Subject: Response to Information Request Permit Modification (with Notice) Request Mesquite Creek Landfill, MSW Permit No. 66B New Braunfels, Comal and Guadalupe Counties, Texas Tracking No. 25969093; RN100218676/CN600127856

RESPONSE TO COMMENTS

Page 4F1-8

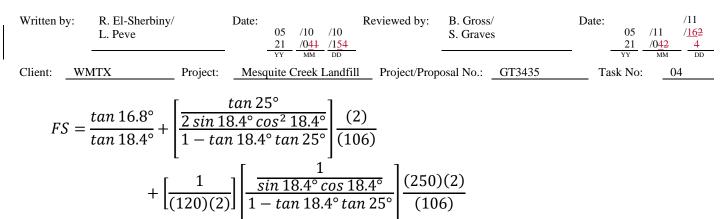
c. Provide design requirements for the soil buttress referenced in page 4F-10 and the achieved FS. In Appendix 4F, page 4F1-10 provides the calculation of the 1.00 for the FS. Existing text next to this calculation indicates that "soil buttress required for stability."

c. The term "soil buttress" is not a distinct feature to be designed/constructed but rather refers to the protective cover soil at the toe of the slope. This wedge of protective cover soil at the toe of slope provides resistance against sliding in the veneer stability calculation, which is based on the Giroud et al. (1995) method. It is not a separate feature or requirement. The unnecessary "soil buttress" terminology in the Appendix 4F has been removed for clarity, and replacement pages are provided with this response.
